Sub.: To Request for action on letter submitted on date 06.01.2023

We would like to draw your kind attention towards our letter submitted on 06.01.2023 to Urban Development [1] Dept. regarding the subject of **Suggestions from CREDAI-MCHI with regard to amendment in DCPR 2034 towards elevation feature for iconic building** (copy attached)

Sub: Suggestions from CREDAI-MCHI with regard to amendment in DCPR 2034 towards Elevation feature for Iconic Building

Illustrations

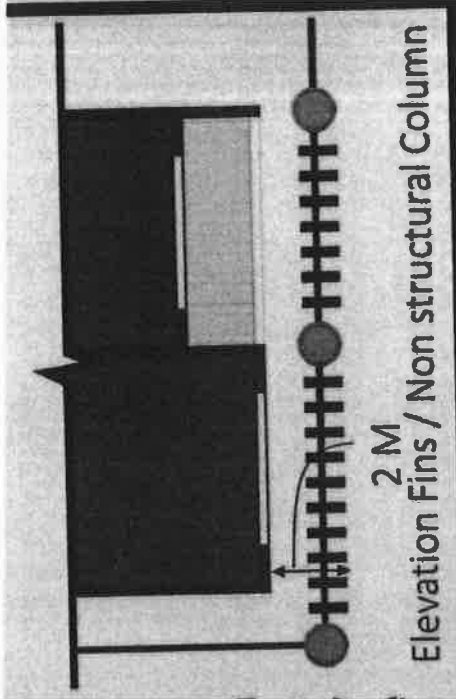
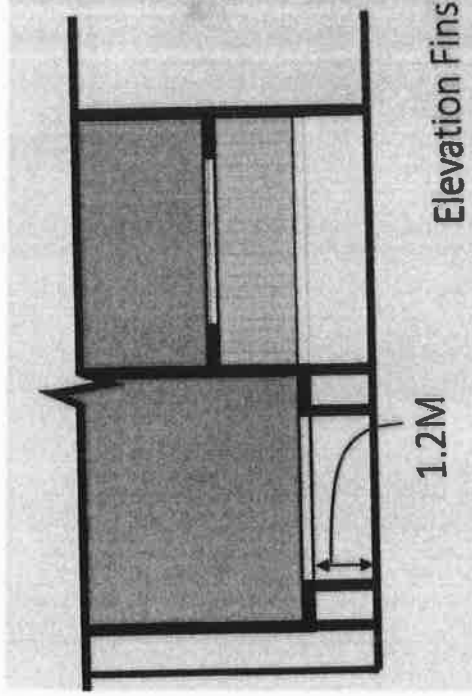
DCR Regulation	Existing Regulation	Proposed Regulation
Regulation 42 (e)(i)	A chajja, cornice, weather shade, sun-breaker; at lintel level, only and Vertical fins (excluding columns) projecting not more than 1.2 m from the face of the building.	Regulation 42 (e) <u>Vertical Elevation members :-</u> Non-structural vertical solid columns / pillars / fins of any shape and size within projection not more than 2.0 m from a building line (i) <u>Horizontal Elevation member :-</u> a) Ornamental projection, cornice , flower beds etc projecting not more than 2.0 m from building line at + 45 cm level from private Habitable floor. No ornamental projection, flower beds, etc. shall be permissible, which will reduce the width of the required open space to less than 2.5 m Further ornamental projections etc. shall be permissible upto 0.60 m in Gaothan area for the plots admeasuring up to 250 sqm. However, in case of redevelopment scheme under Regulation No.33(7) where marginal distances are less, ornamental projection maximum up to 0.45 m may be allowed. b) Horizontal A chajja weather shade, sun-breaker of any shape projecting not more than 1.2m from building line ; at level not less than + or - 45cm from habitable floor level. Ornamental mouldings may be allowed of width not more than 45 cm . No chajja, weather shade, sun-breaker etc. shall reduce the width of the required open space to less than 2.5 m. Further chajja, weather shade, sun breaker projections etc. shall be permissible upto 0.60 m in Gaothan area for the plots admeasuring upto 250 sqm. However, in case of redevelopment scheme under Regulation No.33(7) where marginal distances are less, chajja projection maximum up to 0.45 m may be allowed. c) Chajja , weather shed of various aesthetic shapes will be allowed with the special permission of commissioner. d) Box elevation :- Horizontal Box elevation up to a depth of 1.2m will be allowed with RCC wall at building line and Top of Box elevation shall be at + 50cm from Habitable slab. (ii) A.C. Plat forms :- Platform of width with safety railing not more than 1.2 m and length 2.0 m at the height not less than + OR - 0.60 m above floor level for installation of Air-conditioning split unit not reducing the open spaces as per above , Full height ornamental. Louvers will be allowed for elevation purpose

31(xxxiv):

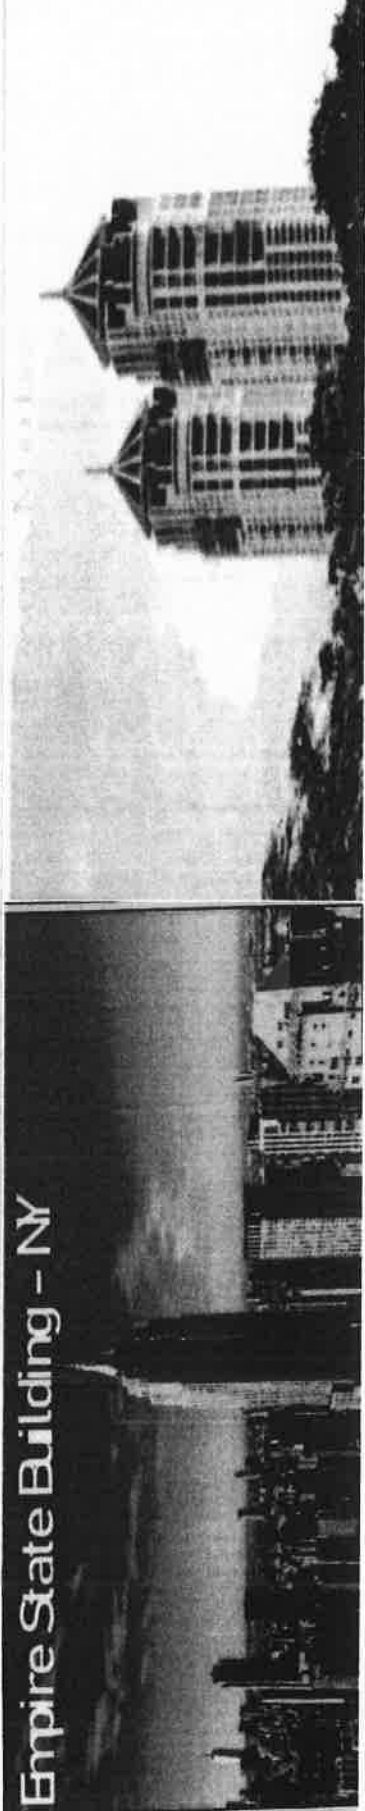
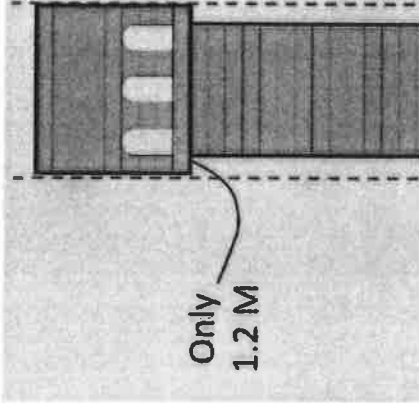
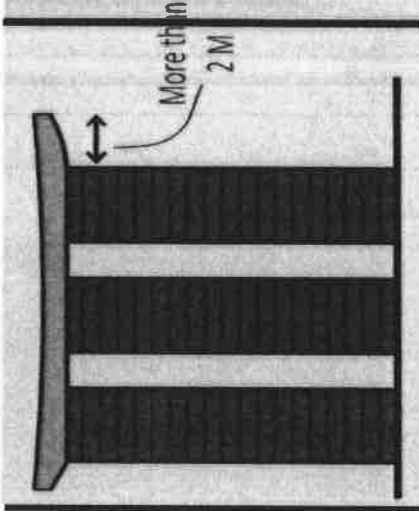
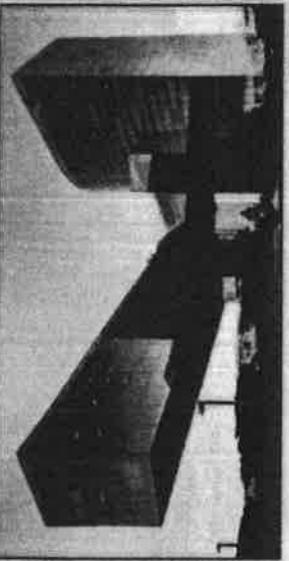
Elevation feature or dome like structure above water tank/lift machine room/staircase room up to 2 m for building with height beyond 32 m & up to 70 m, 6 m for the building height beyond 70 m and up to 120 m and up to 9 m for building with height beyond 120 m

Crown features like dome etc on terrace of desired height with or without covering of terraces provided that covered terrace area is used for Community centre as per regulation 37(28) with special permission of commissioner

Illustration	 Only 1.2 M	 More than 2 M

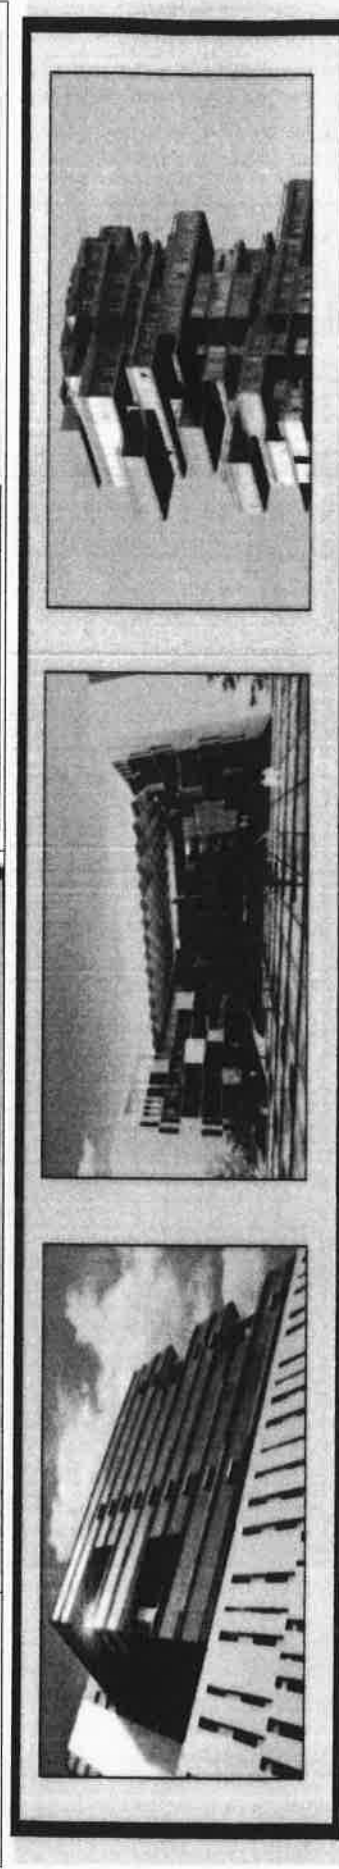
DCR Regulation	Existing Regulation	Proposed Regulation
Regulation 37 (22)	Overhang of terrace to the extent of 1.20 m beyond building line subject to requirement of open spaces as per Regulation no 42(e) & 42(f) may be allowed from elevation point of view	37(22): Common Terraces: Common Terraces shall not be sub-divided and shall be accessible by a common staircases/lift. The terraces may be used for additional recreational green area over and above the mandatory LOS requirement under these Regulations, provided that the terrace shall be designed and made impervious considering recreational green area. The terraces will also serve as community open spaces for the occupants of the building. The terraces may allowed for roof top farming/ gardening Overhang of terrace to the any extent of 1.20 m beyond building line subject to requirement of open spaces as required under regulation No 47 or with permission of Chief Fire Officer.

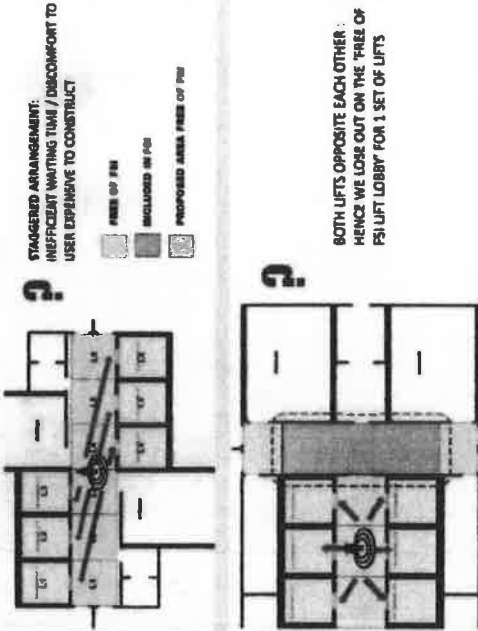
DCR Regulation	Existing Regulation	Proposed Regulation
Regulation 31 (xxi)	Entrance lobbies in stilted portion, height not exceeding 7.2 m. or height equivalent to two floor or height of stilt whichever is more	31(xxi) Entrance lobbies / Atrium in stilted portion, shall be allowed at ground level or at podium level (where covered areas are being used as Community Centre as per regulation 37(28)) of height not exceeding height equivalent to four floor or one eighth of total height of building whichever is more 7.2m. or height equivalent to two floor or height of stilt whichever is more. 31(2) (xviii) : Area of Community Centre provided as per regulation 37(28), Delete:- 31(1) note (ii)
Illustration

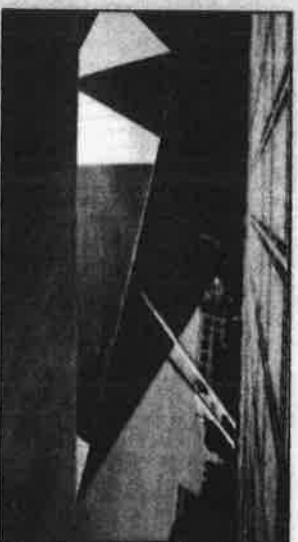
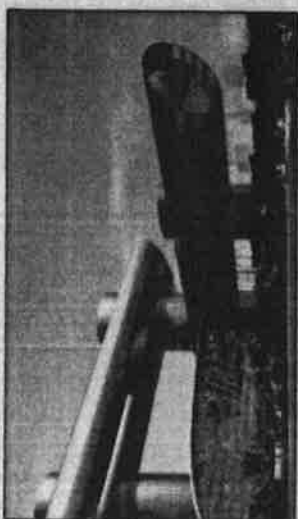
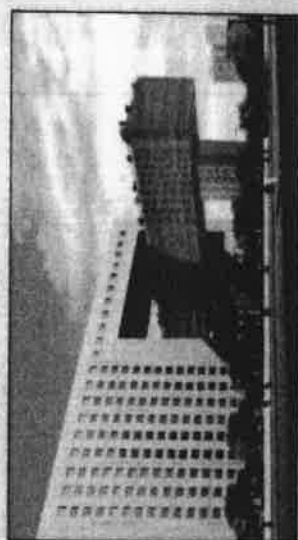
DCR Regulation	Existing Regulation	Proposed Regulation
Regulation 31(xxii) & Note -i)	ii) Open to sky swimming pool at any level other than (xxii) above and excluding at ground level as provided in Regulation No 42 (ii)(a), shall be counted in FSI. xxii) Open to sky swimming pool at the terrace above the top most storey or on the top most podium only	31(xxii)) Open to sky swimming pool at any level (at locations where Community Centre for building is provided) other than private habitable level the terrace above the top most storey or on the top most podium only.
Illustration	 Club house on terrace Podium top with swimming pool	 Club House and Swimming pool on cantilever floor Garden cantilevers permitted if it lack limitations

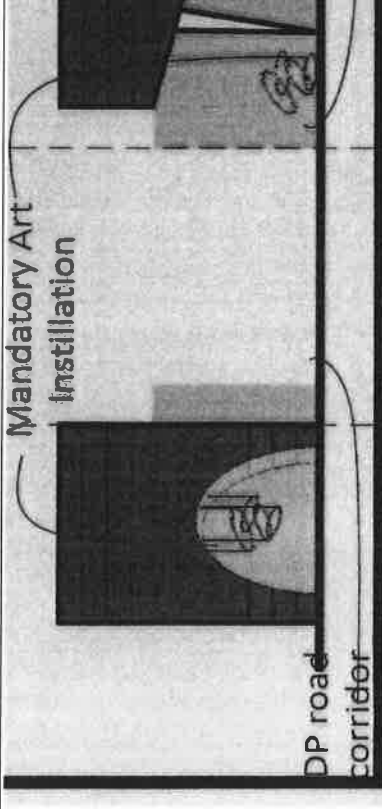
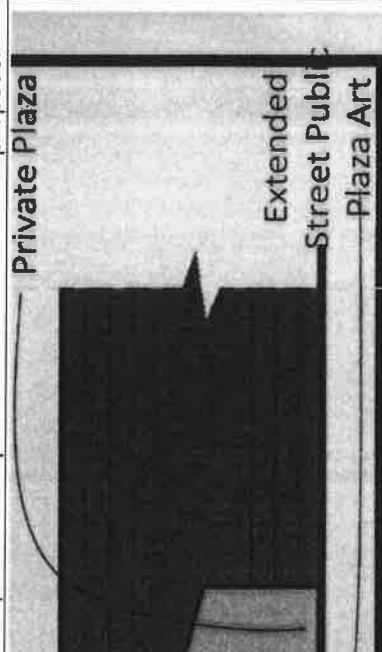
DCR Regulation	Existing Regulation	Proposed Regulation
Regulation 31(1) (iv)	Areas covered by staircases/lift wells including lobbies as specified, excluding those covered under D.C. Regulation No. 31(1) (iii) with special written permission of the commissioner subject to payment of premium.	31(1) (iv) Areas covered by staircases/lift wells including lobbies and passage leading to more than one unit as specified, excluding those covered under DC Regulation No.31 (1) (iii) wit
Illustration

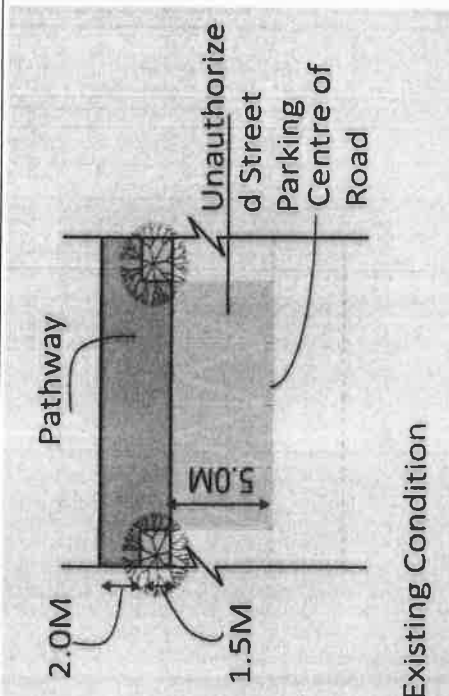
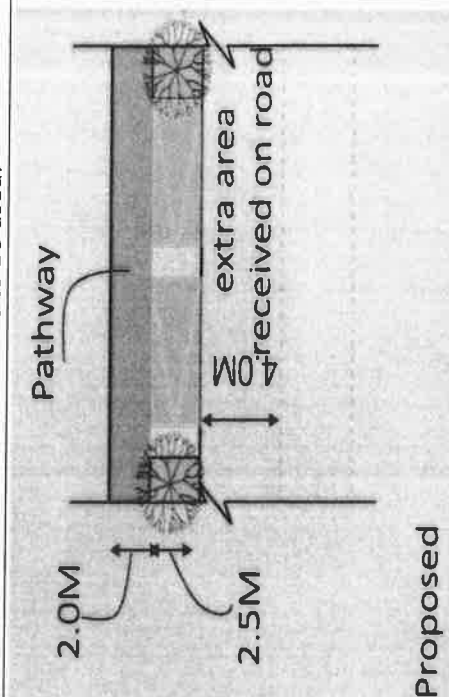
DCR Regulation	Existing Regulation	Proposed Regulation
Regulation 37 (32)	Service floor : Service floor of the height not exceeding 1.8 mtrs may be provided in the building exclusively for the provision/ diversion of services. provided further that a service floor with height exceeding 1.8 m may be allowed in a building of medical use or in building height more than 70 m with special permission of commissi ssone with reasons recorded in writing	37 (32) Service Floor: A service floor of any height not exceeding 1.8 m may be provided in a building exclusively for provision/diversion of services / MEP equipment subject to requirement from MEP Consultant :

Illustration

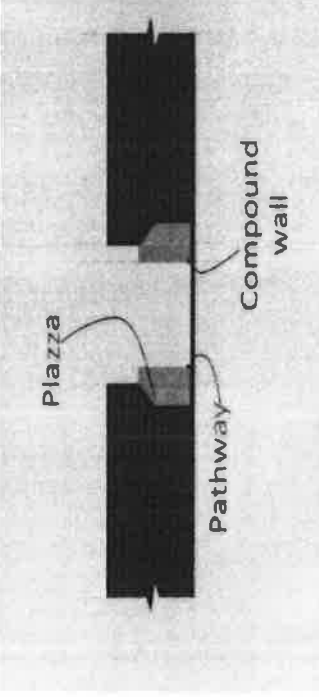
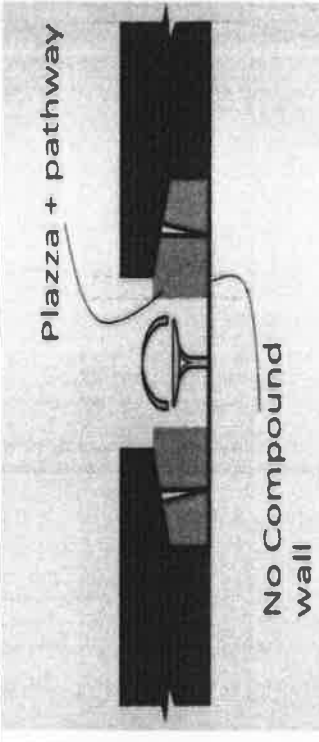
DCR Regulation	Existing Regulation	Proposed Regulation
Regulation 37 (19)	A cantilevered and unenclosed canopy over common entrance and each common staircase not more than 5.5 M. long and atleast 2.2 M. above ground level. The outer edge of the canopy shall be atleast 1.5 M. from plot boundary. An unenclosed porch open on three sides, not more than 5.5 M. in length parallel to the main building in front of common entrance only and expect rear open space. No part of such porch shall be less than 1.5 M. from the plot boundary.	37(18) Porch: A porch, if any, of any length and width shall be at least 1.5 m clear of the plot boundary, shall have a level difference of 0.3 m in relation to the level of the floor; the area of a porch upto 5.5 m in length (parallel to the main building) shall not be counted towards FSI. A parapet wall not more than 1.5 m 0.23 m in height is permissible over a porch. The Commissioner may permit larger porches for mercantile, institutional, IT, Mall, Commercial, hotel and public buildings. 37 (19) Canopy: A cantilevered and un-enclosed canopy of any length and width with level difference of 0.3 m in relation to the floor level may be permitted over each entrance and staircase, if a clear distance of at least 1.5 m is maintained between the plot boundary and the outer edge of the canopy. The minimum clear height of the canopy shall be 2.2 m.
